SUNNYVALE WATER POLLUTION CONTROL PLANT MASTER PLAN

Final Program Environmental Impact Report

Prepared for
City of Sunnyvale

July 2016

Figure RTC-1
Channels and Ponds in the Master Plan Vicinity

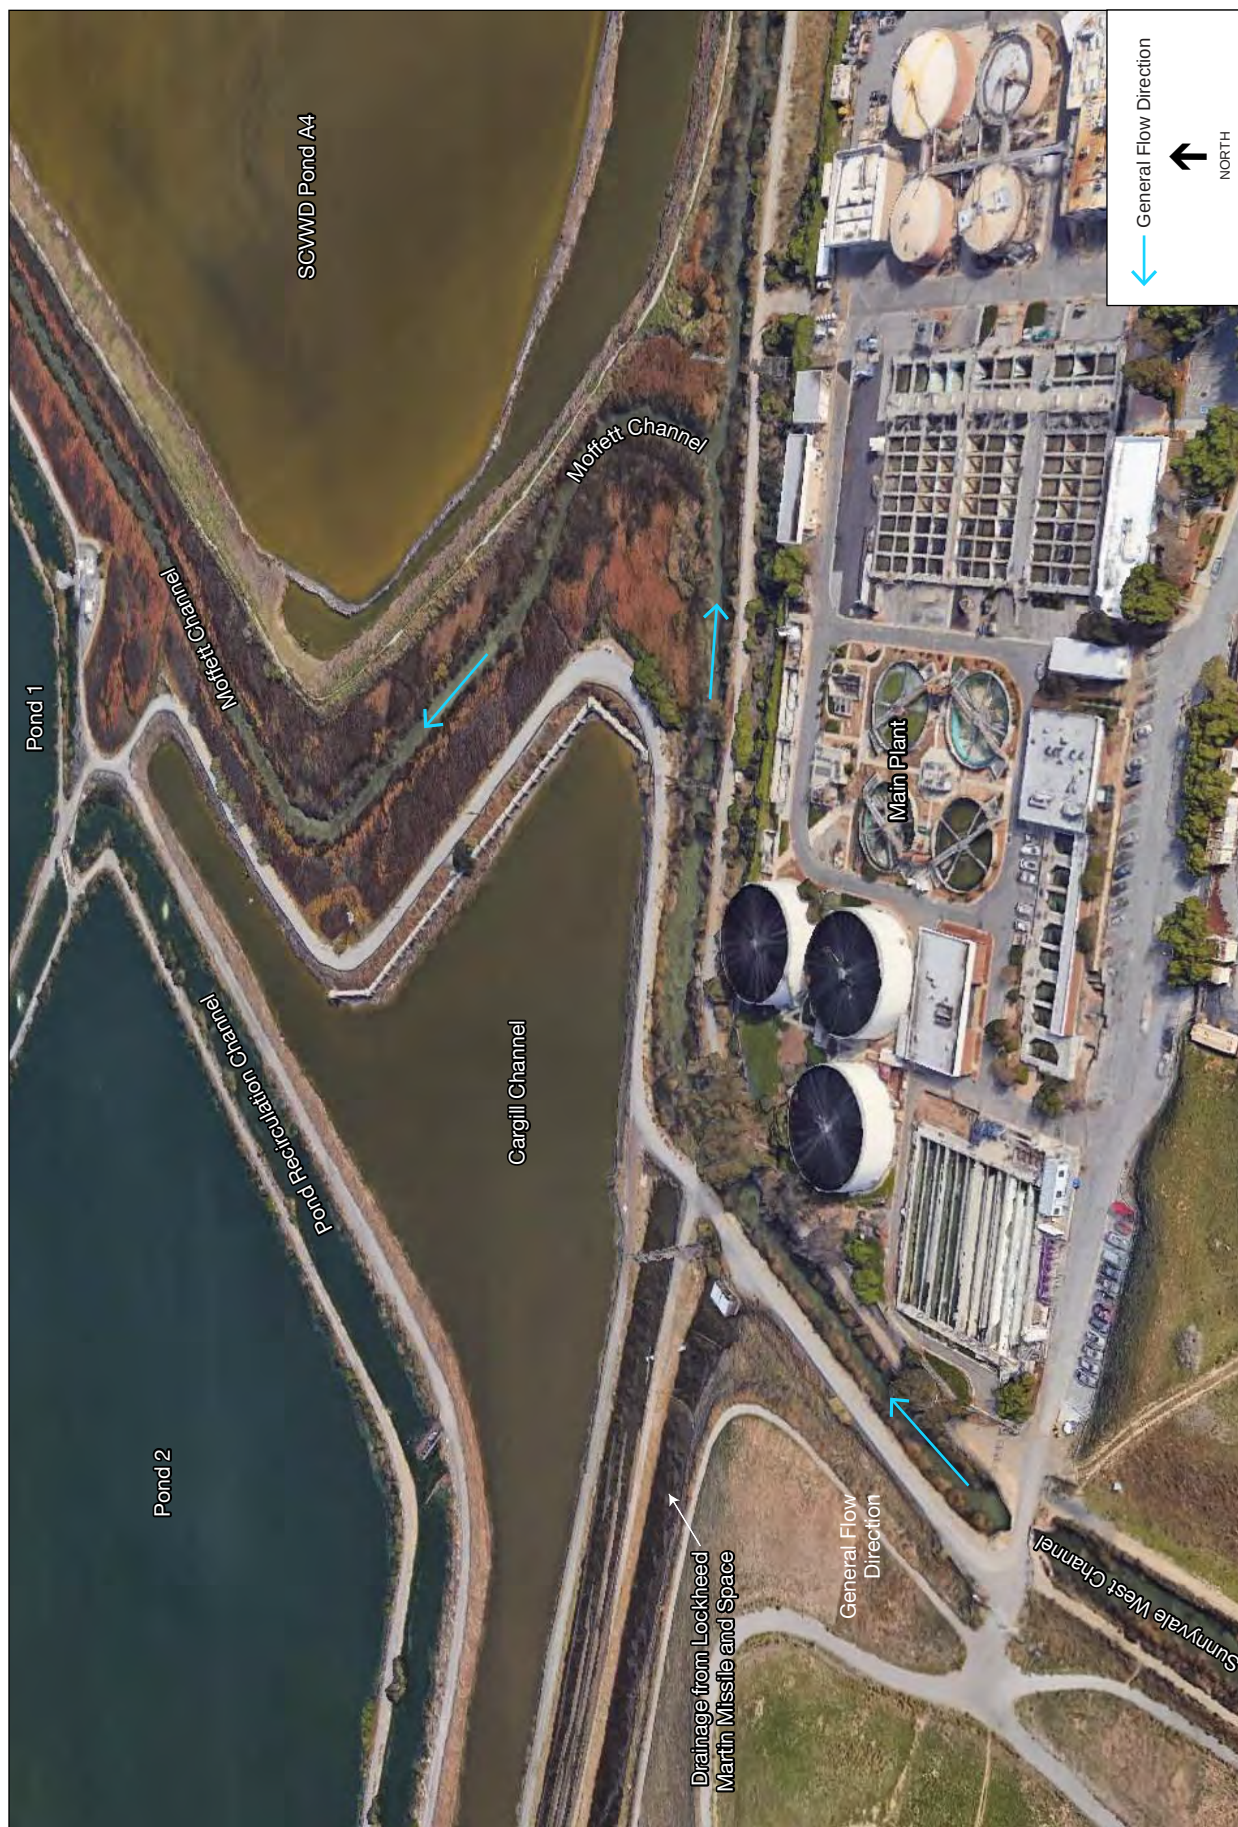
The commenter questions whether runoff from Moffett Field and the Lockheed complex is routed to the Cargill Channel, and whether Cargill Channel can clear flows to the Bay. **Figure RTC-1** shows a closer view of the channels and ponds in the Master Plan vicinity, and is included here for reference. The Moffett Park area is served by two drainage systems: the City of Sunnyvale's storm drain system and the Lockheed Martin Missile and Space drainage features. Drainage from the Lockheed Martin drainage system flows north to a channel that is not connected to Cargill Channel (referred to by the commenter as the Northern Channel) but instead is emptied by a pump station that lifts water into the Sunnyvale West Channel (City of Sunnyvale, 2004). As noted above, Cargill Channel is disconnected from fluvial flows, and water from the channel is not connected to the bay via surface drainage.
